STANDARD NOTES FOR EL PASO COUNTY GRADING AND EROSION CONTROL PLANS

EARLY GRADING AND EROSION CONTROL PLANS

EARLY GRADING & EROSION CONTROL PLANS

**NORTHWEST RETAINING WALL
TYP. CROSS SECTION**
SCALE: HORIZ: 1"=50'
VERT: 1"=5'

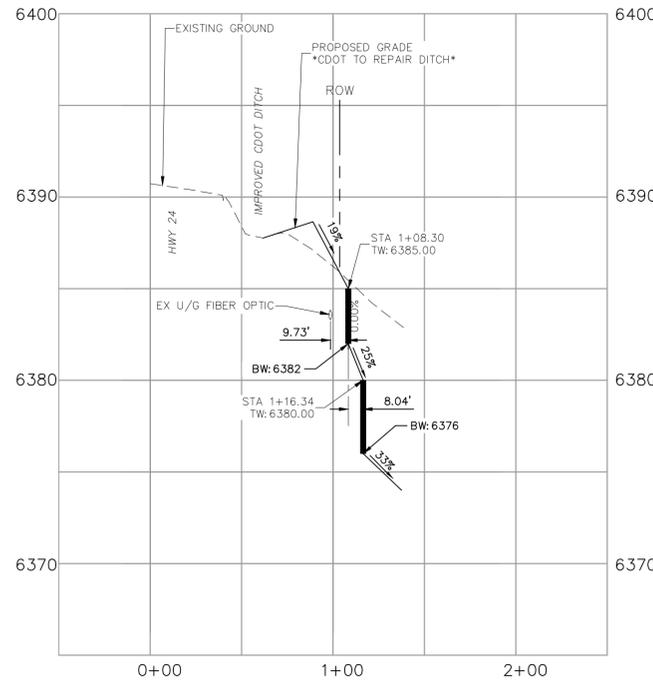
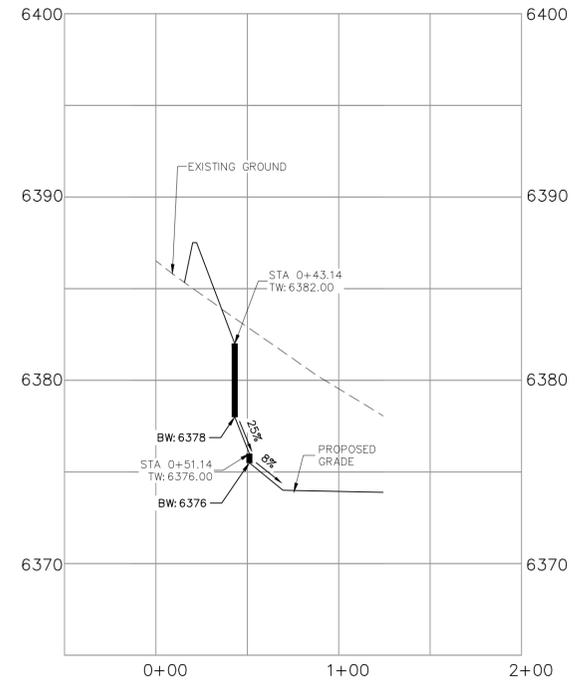
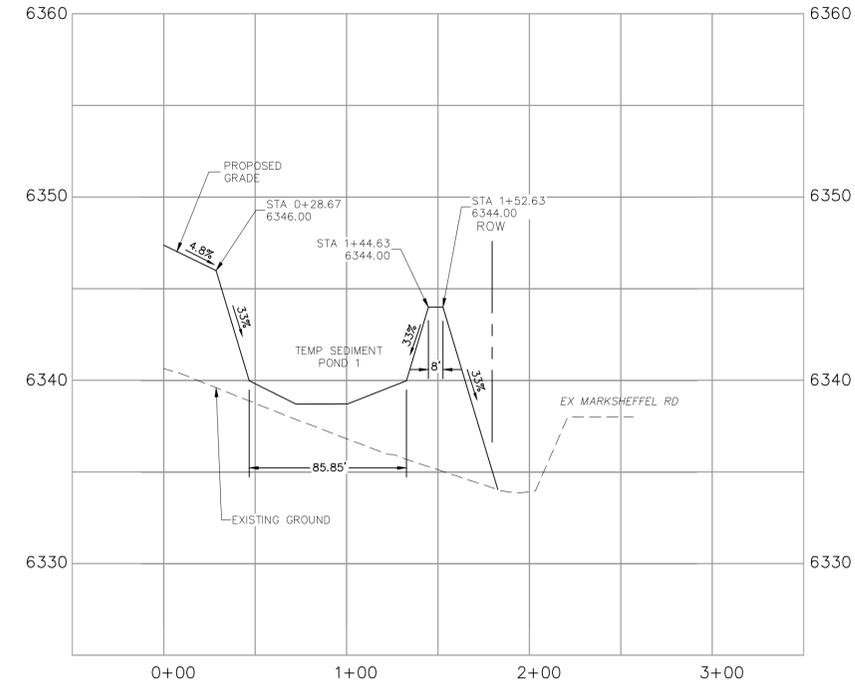
Based on the offset between tiered walls the retaining wall design does not meet the two highlighted sections of the Pikes Peak Regional Building Code Section RBC105.2.1 and will require building permit through PPRBD.

Provide a reference to the retaining wall construction plans and submit a copy of the retaining plans to regional building for review and approval.

The early grading plans will not be approved until the retaining wall plans are approved.

SOUTHEAST POND & BERM TYP. CROSS SECTION
SCALE: HORIZ: 1"=50'
VERT: 1"=5'

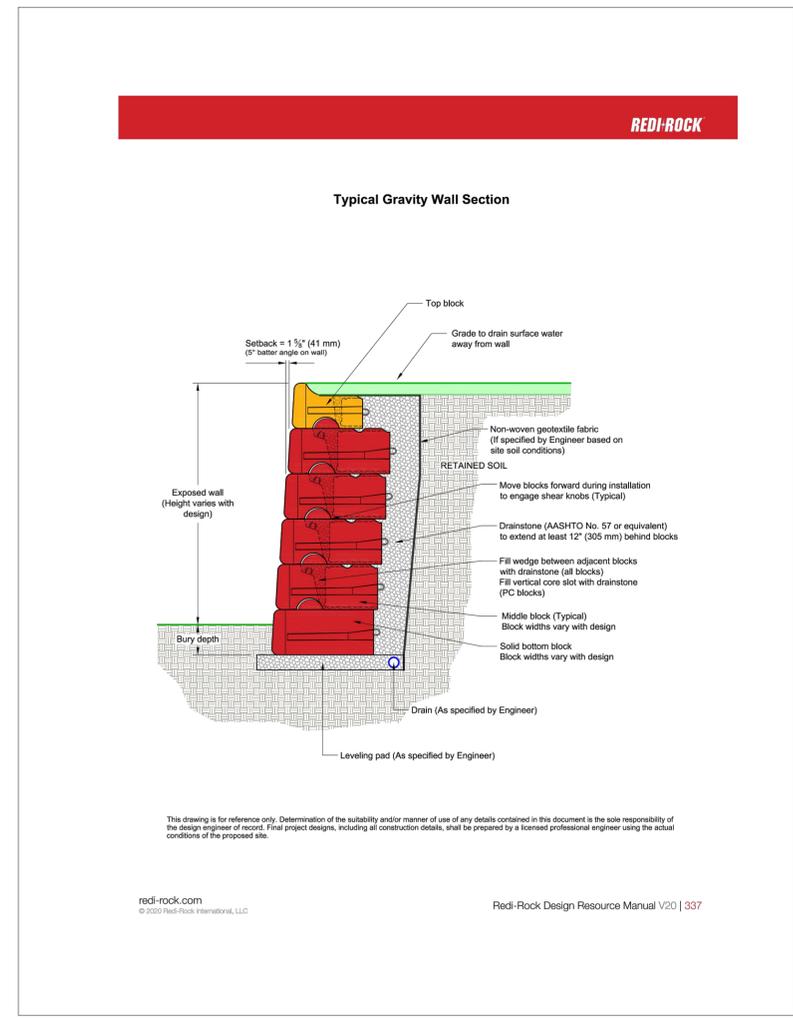
Unresolved from review 3.

Unresolved from review 3. Update to provide a profile view for road improvements.
